Planning App Ref:	PL/2026/00843
Service Ref:	Drainage
Date:	13/03/2026

Full planning permission for the erection of 9no. dwellings including 4 Affordable Homes with associated infrastructure.

Land at Whitlocks, Bishopstone, Wiltshire

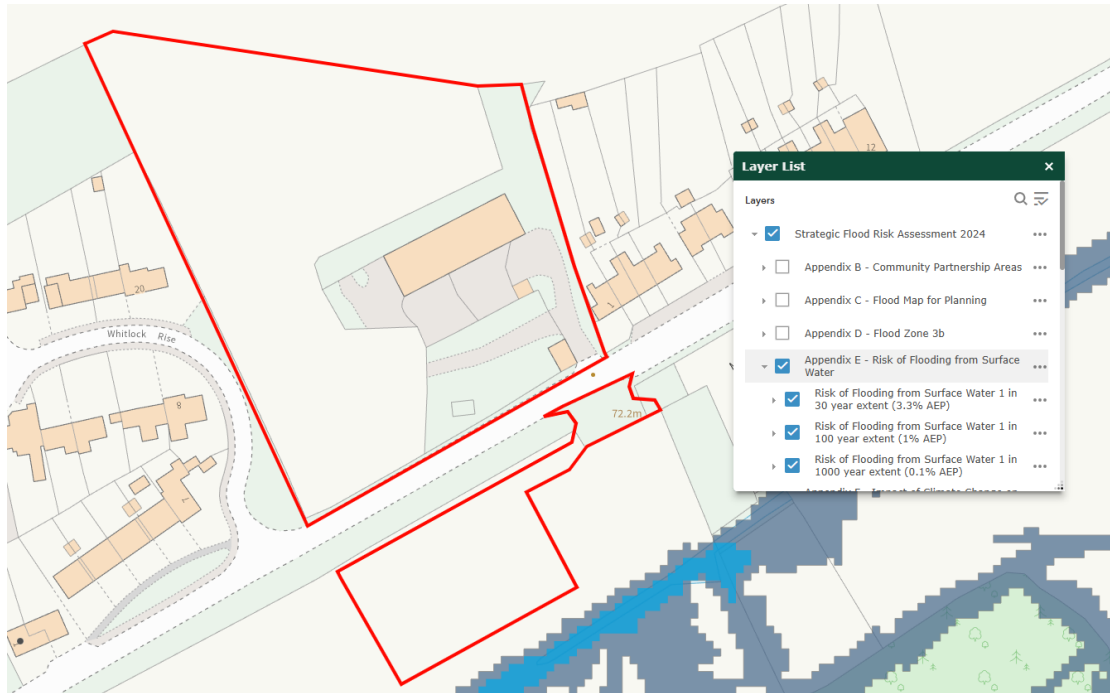
The Wiltshire Council Strategic Flood Risk Assessment, [SFRA Data Explorer](#), has indicated that the site is located within Flood Zone 1 and has a low level of risk from fluvial flooding.

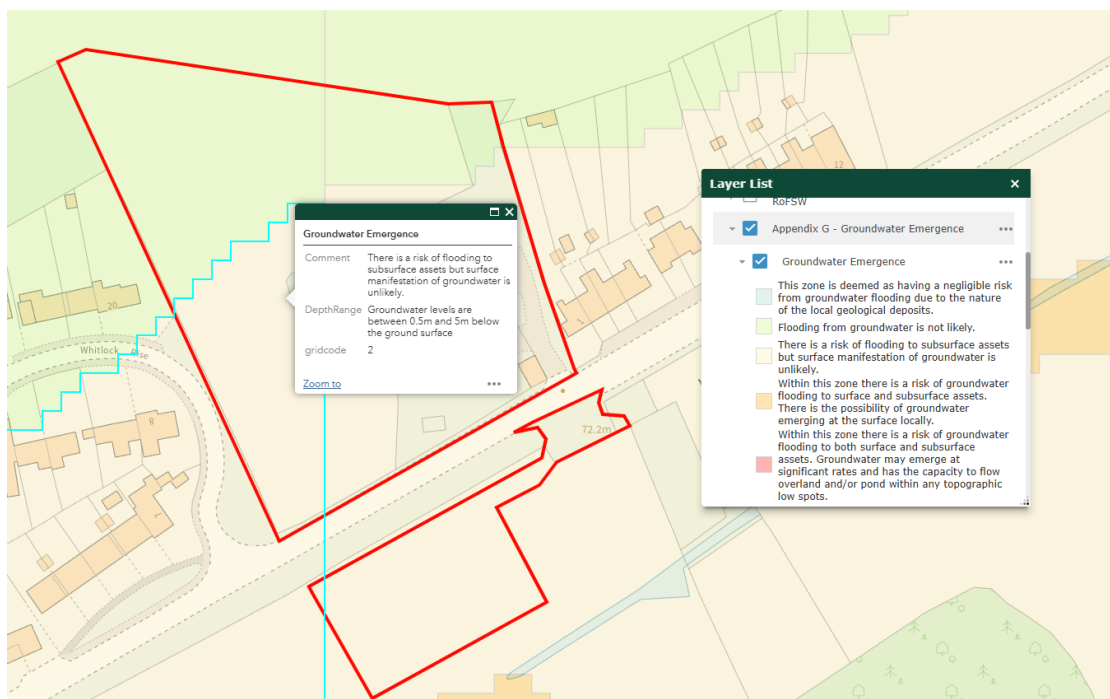
The site has a low level of risk from surface water flooding.
